Please note that this drawing has been issued for Section 19 purposes. The revision clouds and annotation notes are referenced against Revision P04.

Project Title:
South Tyneside College - Listed Building

Drawing Title:
Proposed Floor Plans

Document Status: Construction Issue
Project No: C254A
Drwg No: CAS015-GSSA-LB-ZZ-DR-A-0102
Rev: C03

1. Proposed Basement Plan

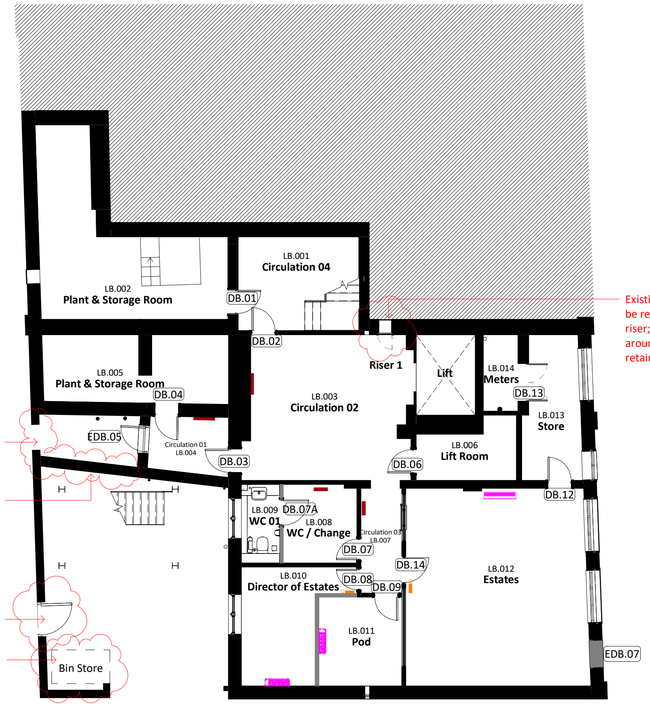
Existing dumb waiter to be re-used as service riser; existing architraves around access hatch to be retained

Existing opening to remain without a gate

Existing courtyard wall to be retained

New galvanised metal courtyard gate

New bin store added

3. Proposed First Floor Plan

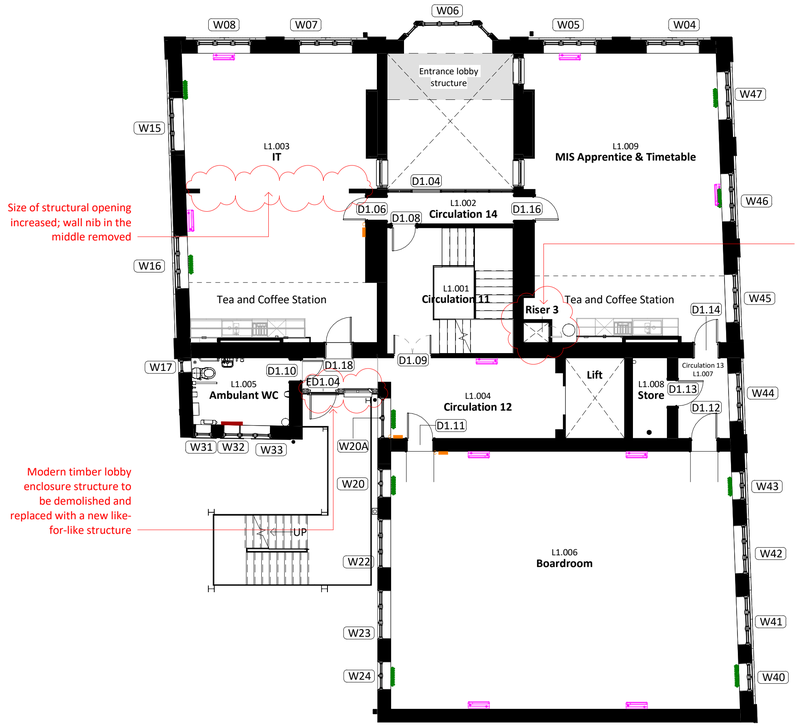
Size of structural opening increased; wall nib in the middle removed

Existing dumb waiter to be re-used as service riser; existing architraves around access hatch to be retained

Modern timber lobby enclosure structure to be demolished and replaced with a new like-for-like structure
